Saab 9-3 - Loss of coolant | HELLA

Engine code: B284.

Chassis no. : 61000001 – 81107480.

Loss of coolant

Figure 1

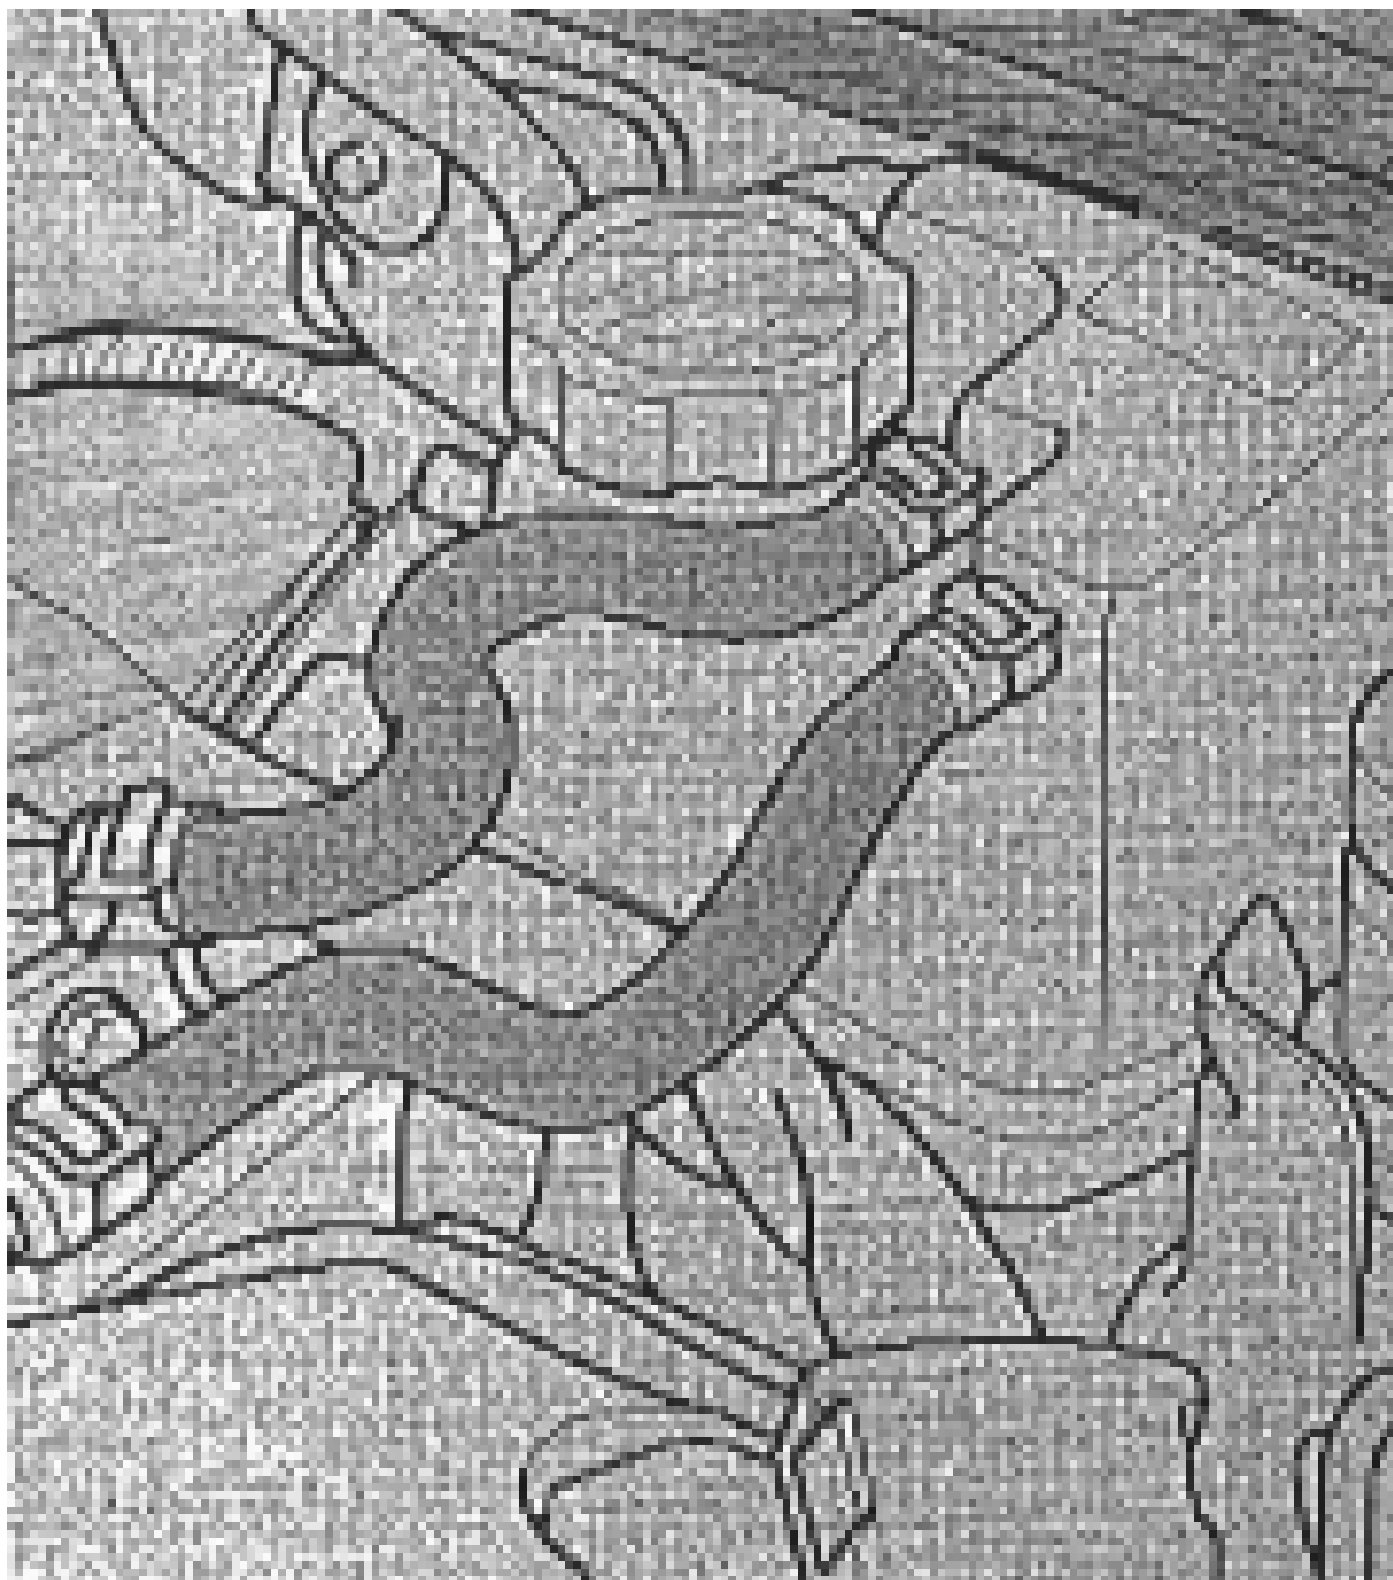
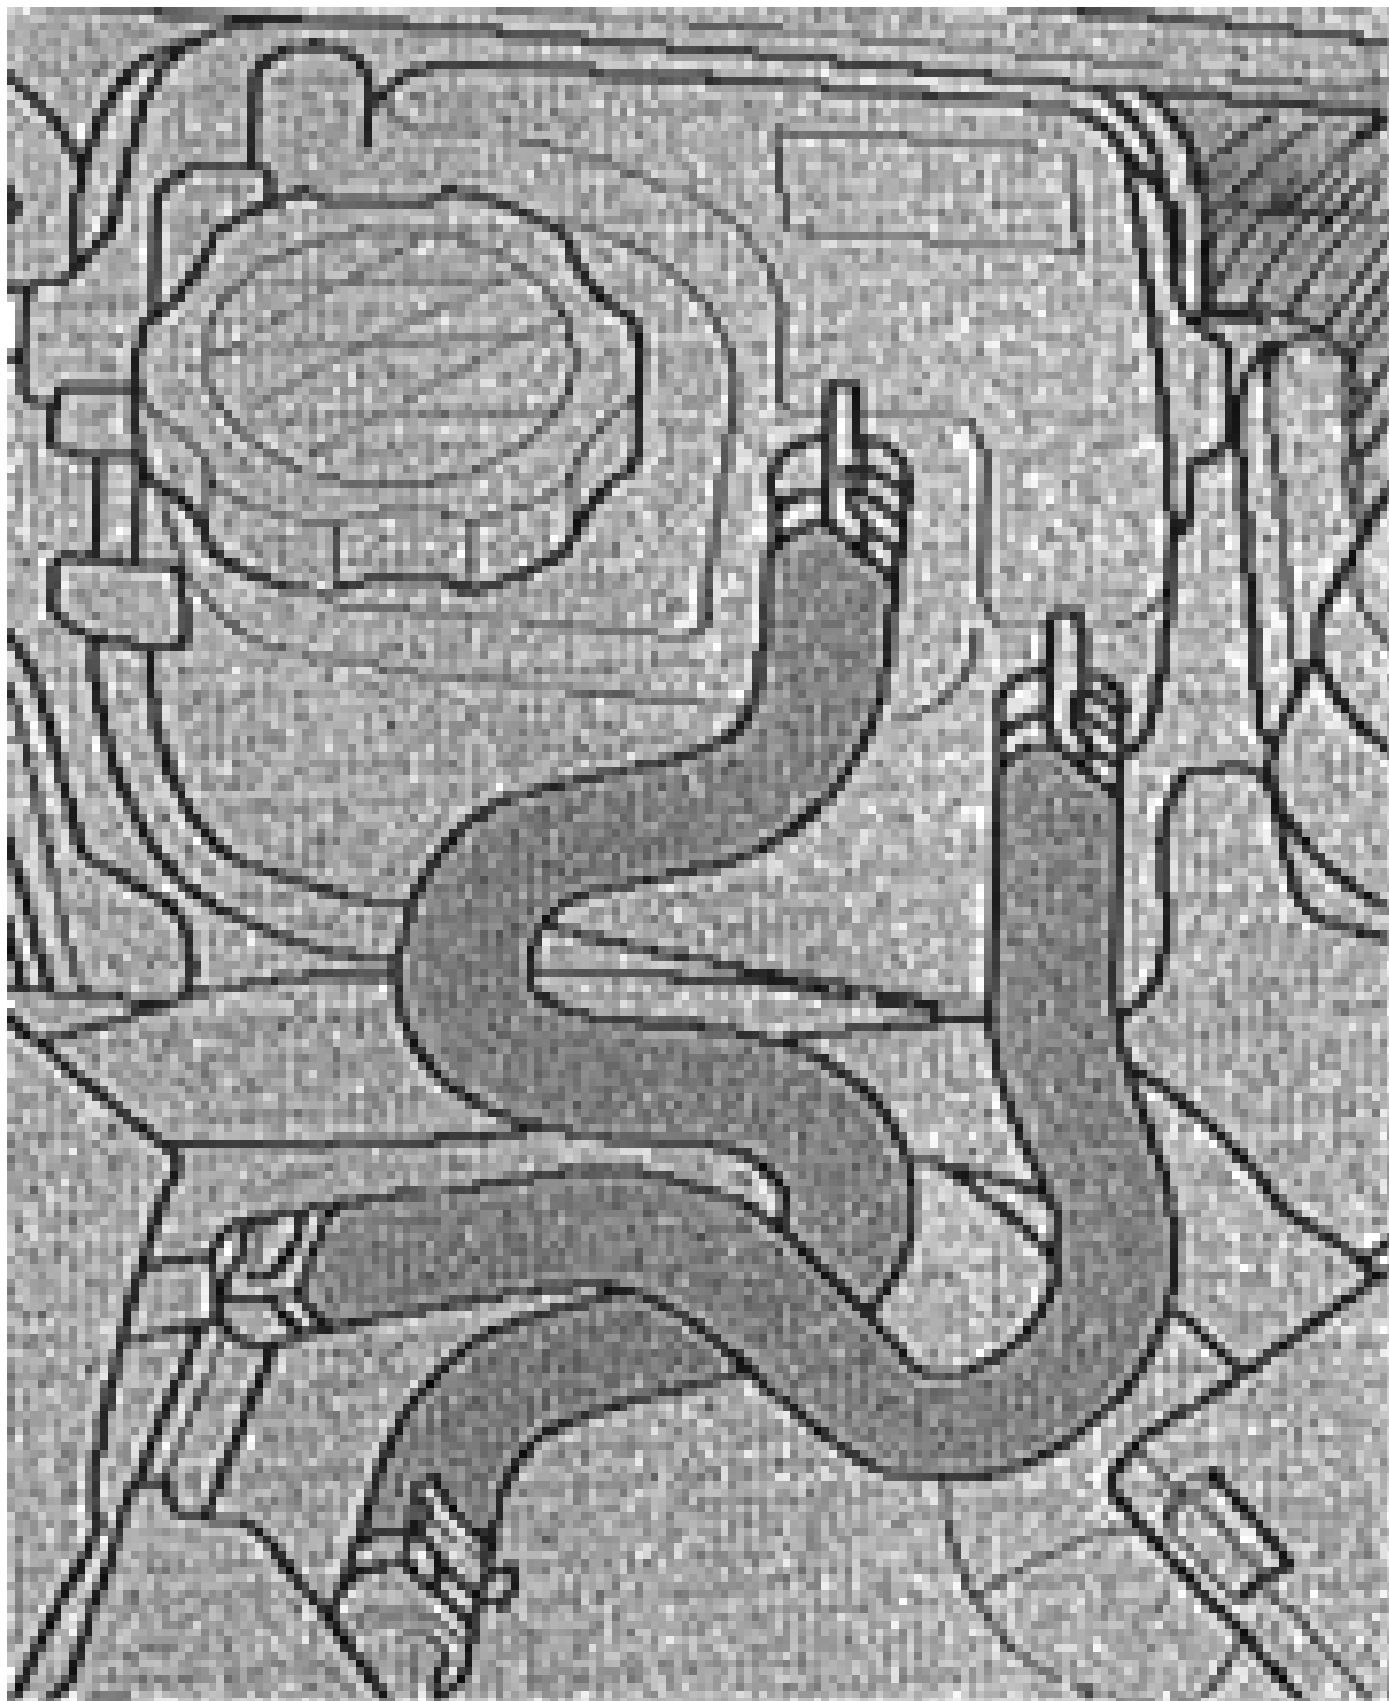
In the case of the above-mentioned vehicles, problems can arise because of loss of coolant. The cause of this can either be a defective coolant expansion tank or damaged engine coolant hoses on the coolant expansion tank.

The positioning of these components (Figure 1) is located very close to the turbo charger, which means that material fatigue can result because of the hot ambient temperature.

In order to remedy this, the coolant expansion tank is to be replaced and the hoses of the coolant expansion tank are also to be replaced / repositioned.

The car manufacturer provides modified coolant hoses for this specific purpose (See Figure 2).

Spare part no: 93 194 927

Spare part no:12 759 330
